PROJECT:	Ogdensburg City School District 2023 Capital Outlay Project 2023-008	DATE SENT:	8/31/2023
		RETURN BY:	9/5/2023
SUBJECT:	FO 104-01 Heated Sidewalk	CHANGE ORDER ALLOWANCE PAY APP ID:	01 (GC) AA-4- 001
TYPE:	Change Order Allowance Pay App	TRANSMITTAL ID:	00177
PURPOSE:	CO/AA For Admin Processing	VIA:	Email
ACTUAL AMOUNT:	(\$4,800.00)	ESTIMATED AMOUNT:	(\$4,800.00)
ACTUAL DAYS:	0	ESTIMATED DAYS:	0

Project:	2023 Capital Outlay Project	Field Order No.:	104-01
Owner:	Ogdensburg City School District 1100 State Street Ogdensburg, New York 13669	Date:	August 4, 2023
Contractor:	D.C. Building Systems, Inc. 19086 US Route 11 Watertown, New York 13601	Architect's Project No.:	2023-008
SED No.:	51-23-00-01-0-007-025 Ogdensburg Free Academy / Golden Dome	Contract For:	No. 1 - General Construction
		Contract Date:	July 3, 2023
		SED Project Manager:	Wendy Clark

RE: Ogdensburg Schools BC01 Heated Sidewalk Undercut

DATE	1	L220
BY		BID SET

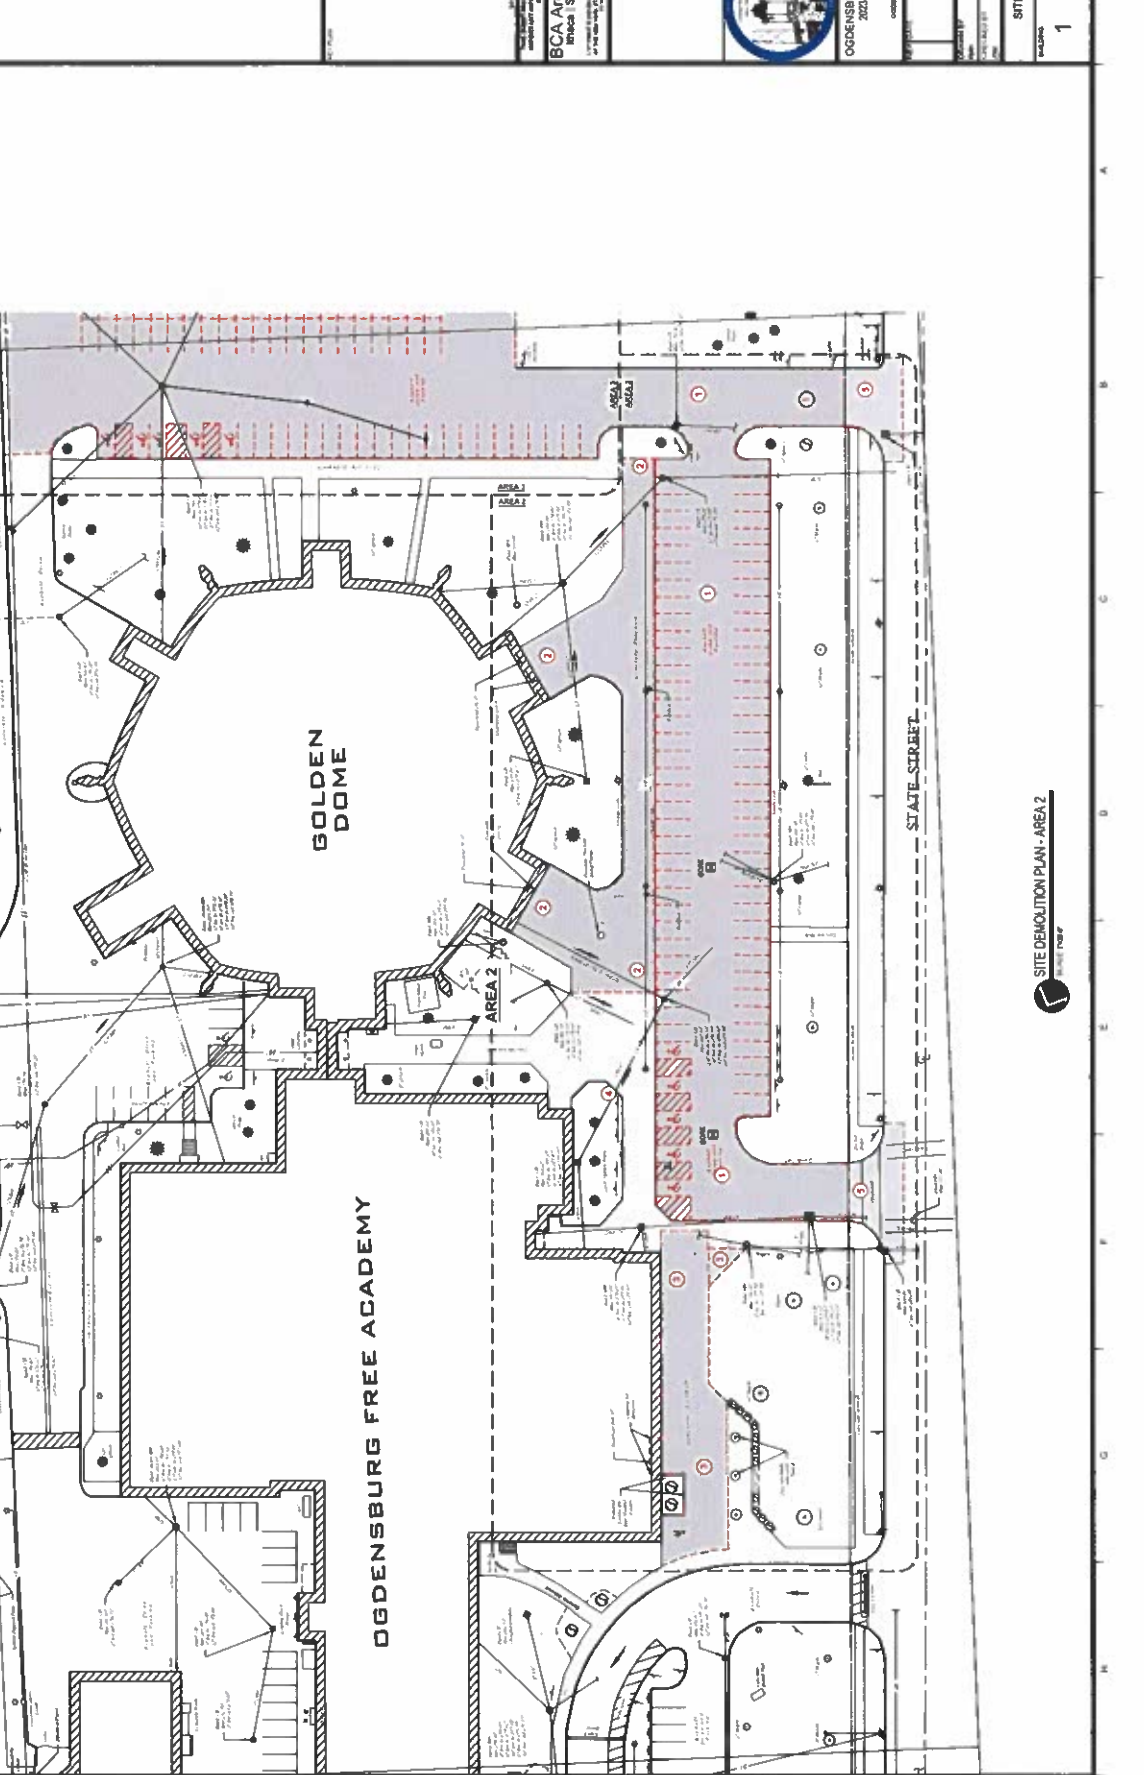
Add to provide all labor, materials, and equipment to undercut existing subbase and provide additional compacted stone over stabilization fabric within footprint of sidewalk replacement along the District & CSE Offices due to presence of unstable clay soils. \$ 4,800.00

Following please find our proposal to perform additional undercut due to existing soil conditions. We will boxout the existing material to minus 12" in lieu of minus 6" detailed and replace it with type 2 stone compacted. Additional material, and trucking of spoils offsite.

A	General Contractor
B	Under the Capital Outlay Project, existing sidewalks were scheduled to be replaced as per Contract Drawing L220 & L320.
C	Upon removal of the existing concrete sidewalk in front of the main entrance at Ogdensburg Free Academy, the General Contractor discovered an unsuitable layer of clay soil immediately below. To avoid future complications of expansion & contraction as the clay reacts to moisture, the subbase was further undercut an additional 6-inches and replaced with compacted granular fill.
D	Add to provide all labor, materials, and equipment to undercut existing subbase and provide additional compacted stone over stabilization fabric within footprint of sidewalk replacement along the District & CSE Offices due to presence of unstable clay soils.
